Further Supplementary BIA report based on Campbell Reith Audit Query – Tracker March 2017

Project Title : Ornan Court, 2 Ornan Road, London, NW3 4PT

This document has been prepared as a response to Campbell Reith's comments as part of the review process.

Google Maps 229 Haverstock Hill

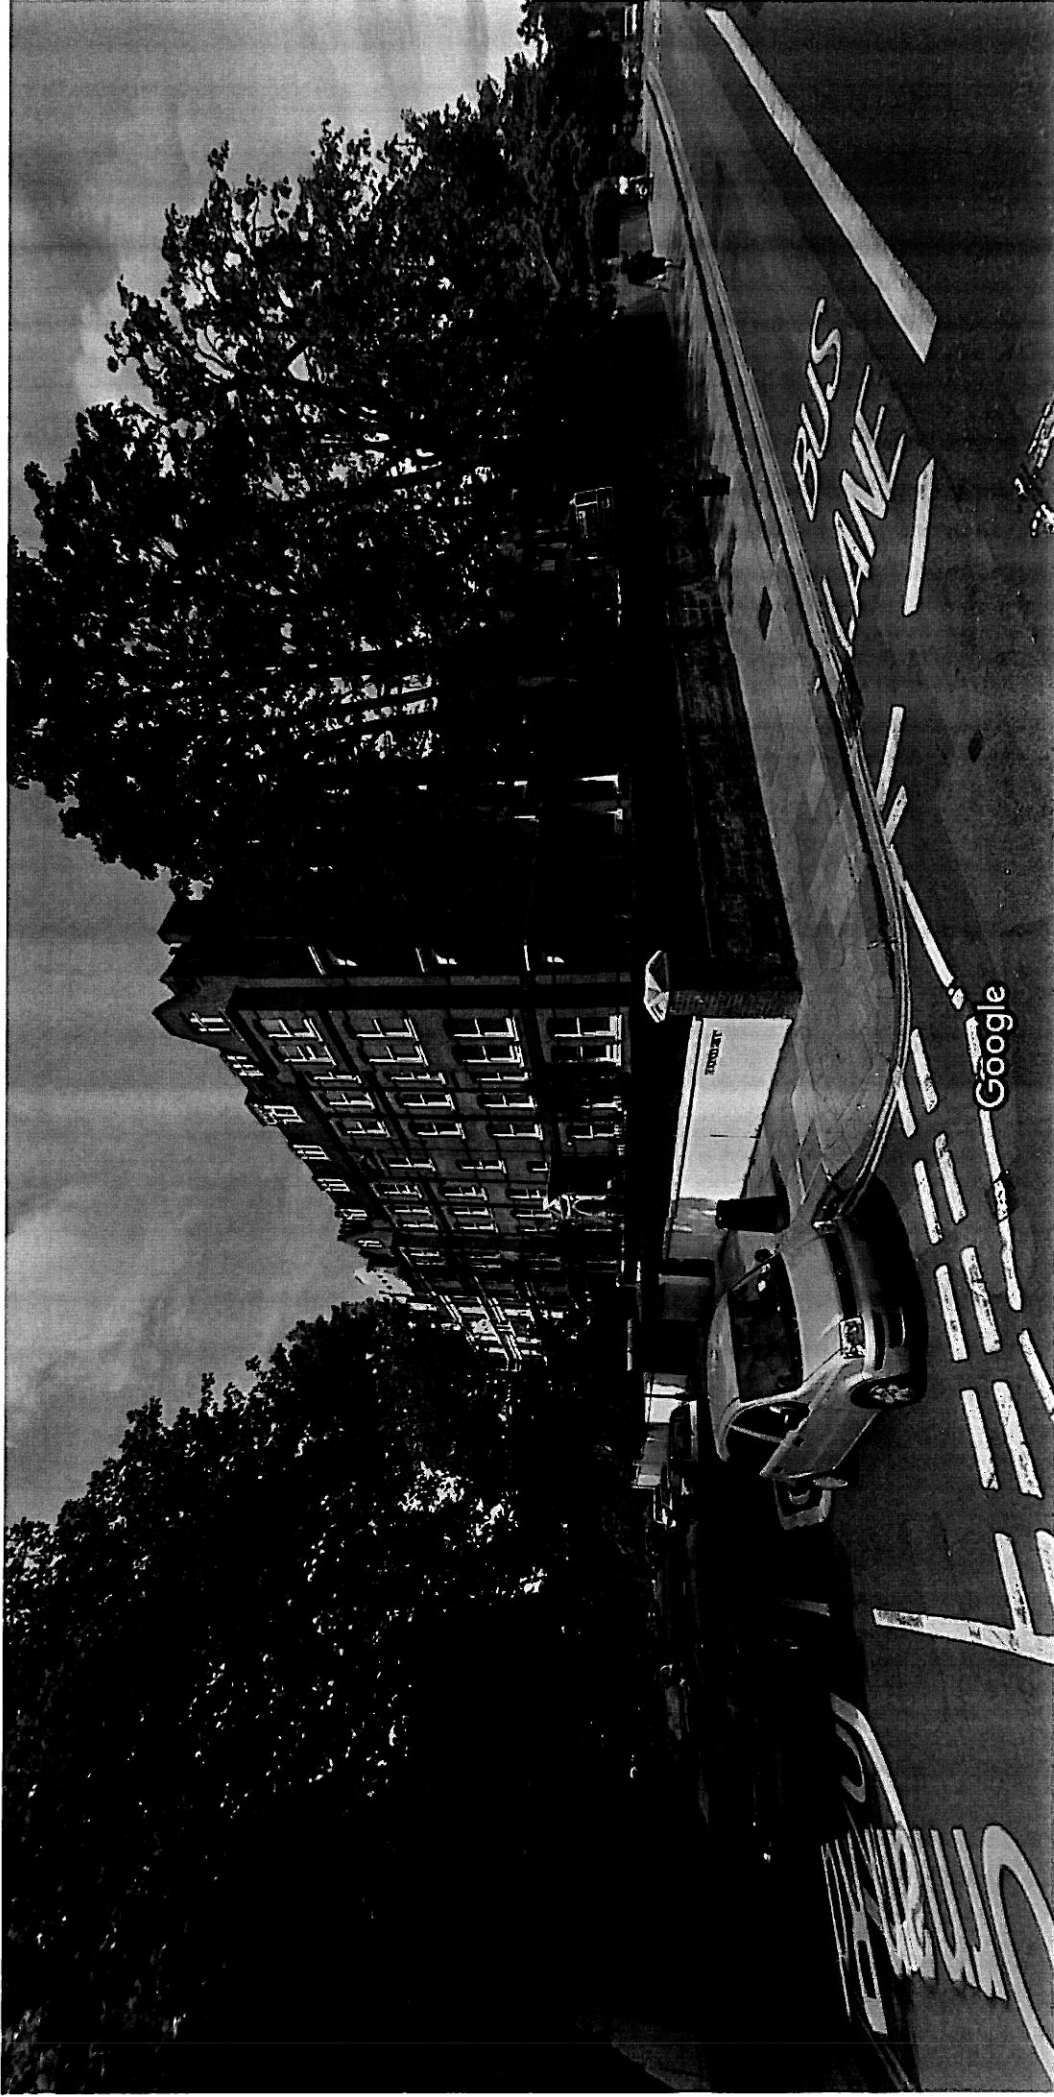
6. Stability - assessment of on-site retaining structures - the supplementary BIA provides outline information on the current repair / upgrade works of the retaining walls that 'will considerably reduce the likelihood of any collapse of these walls in the future'. Some further information should be provided to justify this response, such as dimensions of the retained height and details of the retaining structure. These structures should also be assessed within the quantitative Ground Movement Assessment to indicate if they will be affected by ground movements, and if so what the impacts of those movements will have. It is noted that on page 2 of the Supplementary BIA (4.14) that retained structures are outside the zone of influence of the development, however Fig 2 of the SAS report suggests retaining structures within 5m of the development.

The Haverstock Hill wall is on an outward tilt, most likely resulting from the three mature trees that grow immediately adjacent to it within the property, the 'horizontal bars' installed within the wall are intended to help in this respect. The seasonal movement due to the trees will dwarf any movement from the dig so this wall not considered further.
